RE: SPEX 2008-0017 & CMPT 2008-0007

Loudoun County School Board – Lenah Property

Response to Referral Comments

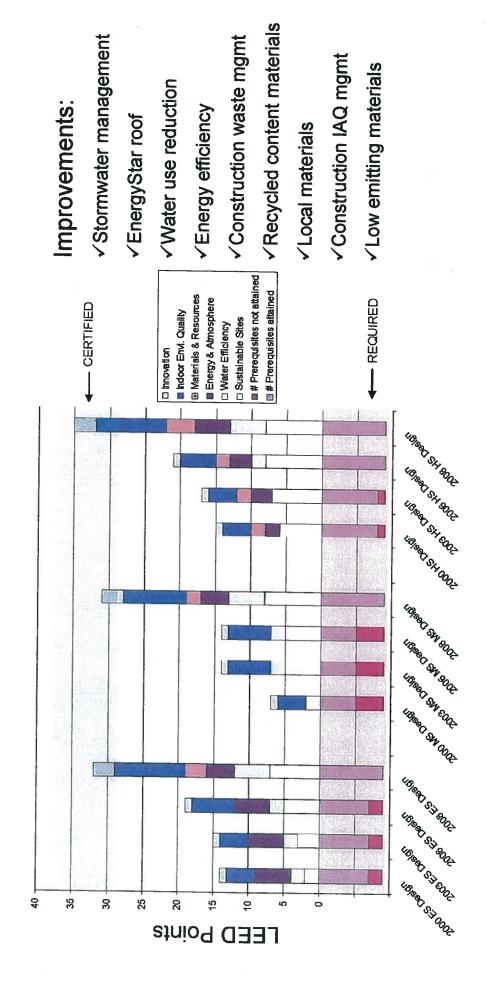
Comment: 11. Staff recommends that the applicant depict the existing and planned pedestrian and bicycle network on the plat with special attention to pedestrian and bicycle facilities along internal roads, the Lenah Connector, and Lenah Road. The applicant should state whether these facilities will be constructed by the applicant or by others. Staff recommends that sidewalks/trails be provided on both sides of all internal roads and that safe crossing facilities be provided at all intersections. Staff also recommends that all bicycle and pedestrian facilities be constructed in accordance with County policies, AASHTO, and ADA. Staff recommends that 5 to 6-foot wide sidewalks be provided on both sides of all internal roads, that the

applicant consider 10-foot paths for areas of high pedestrian traffic, and that safe crossing facilities be provided at all intersections.

Response: A separate pedestrian and bicycle network plan sheet (5) has been added to the SPEX plat to illustrate the proposed network. The facilities shown on the plan are to be constructed by LCPS with the exception of the sidewalk to be constructed as a part of the Lenah Connector Road which will be built by the property owner. The sidewalk on the eastern side of the internal drive has been extended to provide a full sidewalk on the east side complementing the full trail to be provided on the west side. Intersection crossings are also illustrated.
